Union Electric

ULNRC-04861  
TAC No. MB6478

DOCKET NUMBER 50-483  
CALLAWAY PLANT  
UNION ELECTRIC COMPANY  
REVISION TO TECHNICAL SPECIFICATION 5.5.9  
"STEAM GENERATOR (SG) TUBE SURVEILLANCE PROGRAM"  
References: 1) ULNRC-04745 dated October 3, 2002  
2) NRC letter to G. L. Randolph dated February 4, 2003

REQUEST FOR ADDITIONAL INFORMATION  
RELATED TO STEAM GENERATOR TUBE INSPECTION LICENSE AMENDMENT  
UNION ELECTRIC COMPANY  
CALLAWAY PLANT, UNIT 1  
DOCKET NO. 50-483

Figure Q65-1  
 Callaway Non-axial Tubeshet Indications (Below -0.3" from TTS)

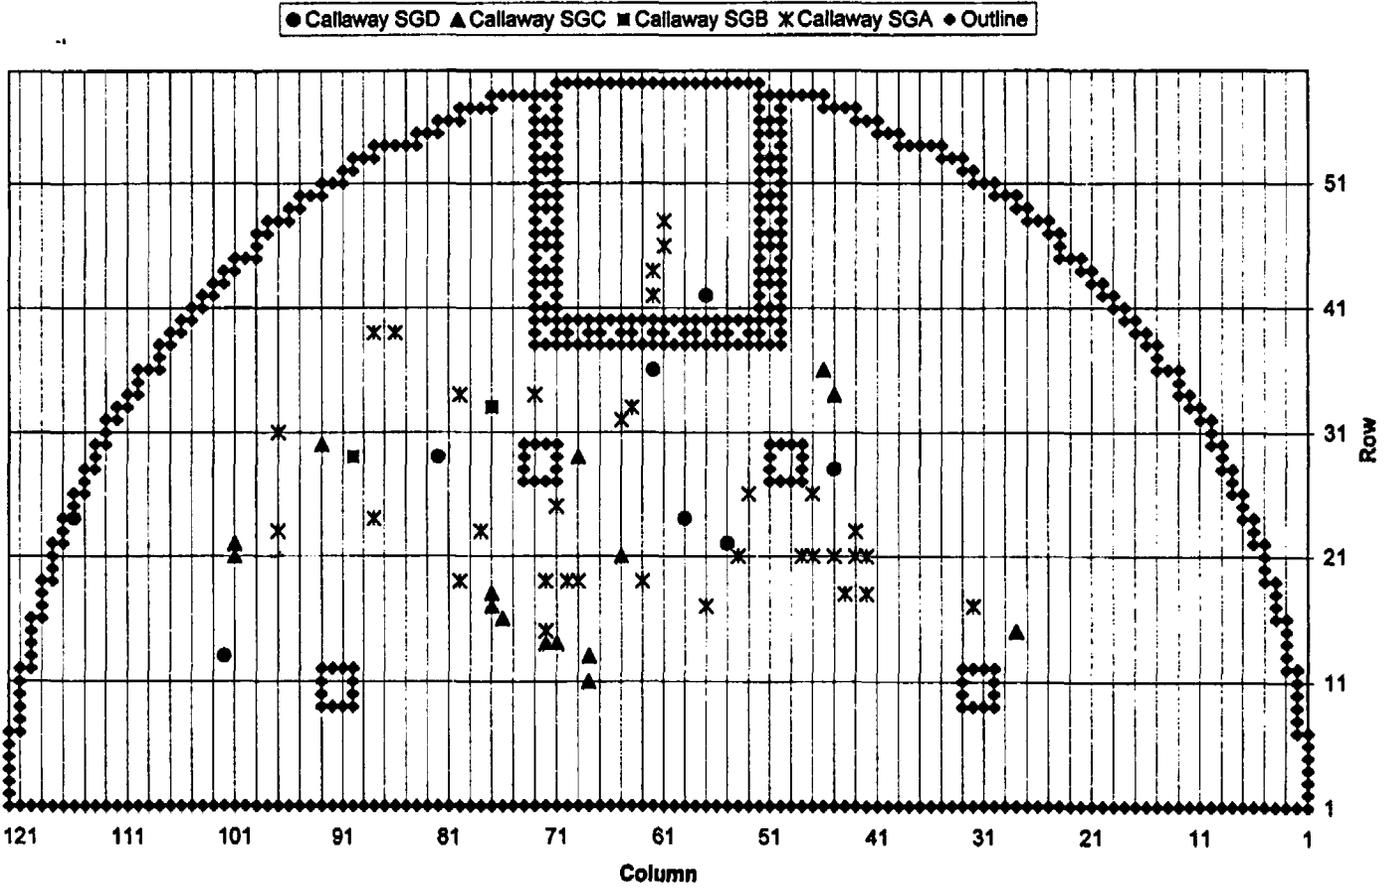
*65. Regarding Figure 14 in the Westinghouse report, SG-SGDA-02-47, and the determination of the distribution of indications below the inspected region, it is not apparent that the methodology presented supports the conclusion that the distribution of indications below the H\* distance is uniform, for the following reasons:*

*Replot Figure 14 based on all indications (regardless of severity, zone, or outage in which they were detected) and also with all indications in specific zones to assess whether the uniform distribution assumption still holds.*

A tubesheet map of Callaway non-axial tubesheet indications below -0.3 inches from the top of the tubesheet is provided in Figure Q65-1. The plot supports a determination that the indications are distributed uniformly in the radial direction outside the thermally treated portion of the tube bundle and part of Zone A. Figure 6.14, "Distribution of Severe Indication Locations" of WCAP-15932, Rev. 1 supports a uniform distribution along the elevation of the tubesheet.
